Subject: April 2013 Exceedence of Salinity Objectives at Emmaton

The State Water Contractors ("SWC") appreciate the opportunity to review and comment on the Draft Environmental Impact Statement/Environmental Impact Report ("EIS/EIR") prepared by the Bureau of Reclamation ("Reclamation") and the San Luis & Delta-Mendota Water Authority ("SLDMWA") for the proposed Long-Term Water Transfers Project (the "Project"). The SWC understand that Reclamation is serving as the lead agency under the National Environmental Policy Act ("NEPA") and that SLDMWA is serving as the lead agency under the California Environmental Quality Act ("CEQA"). These comments are provided by the SWC for both NEPA and CEQA.

The County of Yolo ("County") submits this letter to provide its initial comments on the Long Term Water Transfers Draft Environmental Impact Statement/Environmental Impact Report ("Draft EIS/EIR"). The County is continuing to review the Draft EIS and may submit further comments in early 2015.

Extreme Calendar Year Sac Valley Precipitation Conditions

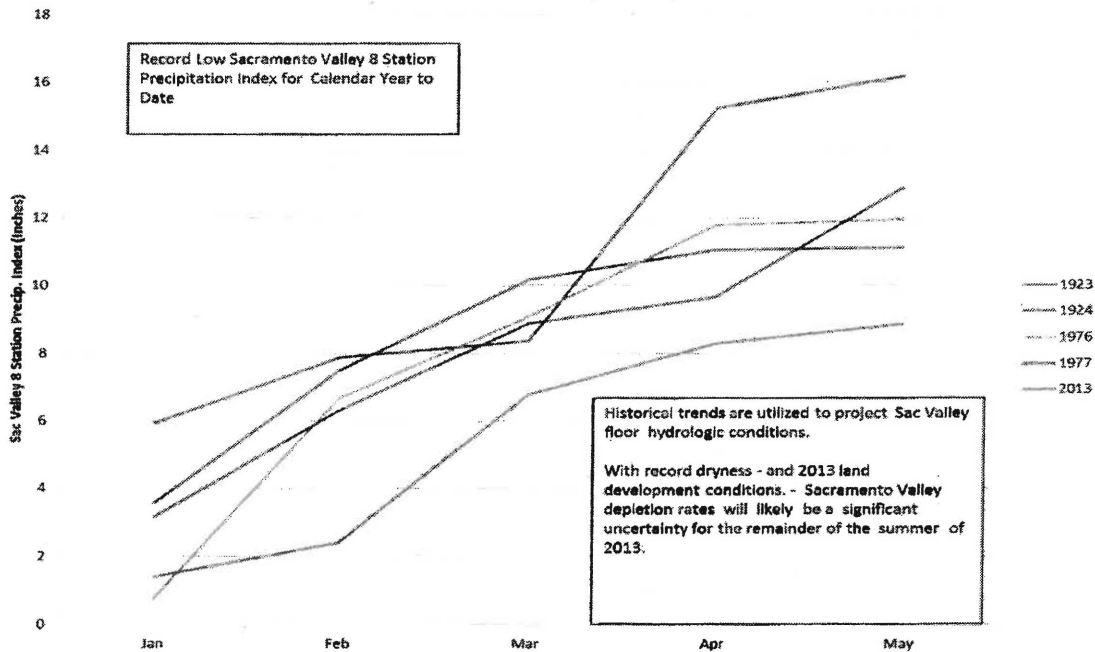
approximately 8.8 inches. Currently, this value represents the driest calendar year period in the long precipitation record--even drier than the very dry single years of 1977 and 1924. Creek and small stream flows that enter the Sacramento River system below major reservoirs are running at historically very low levels in response to this long, dry precipitation period. (Attach 8SI plot)
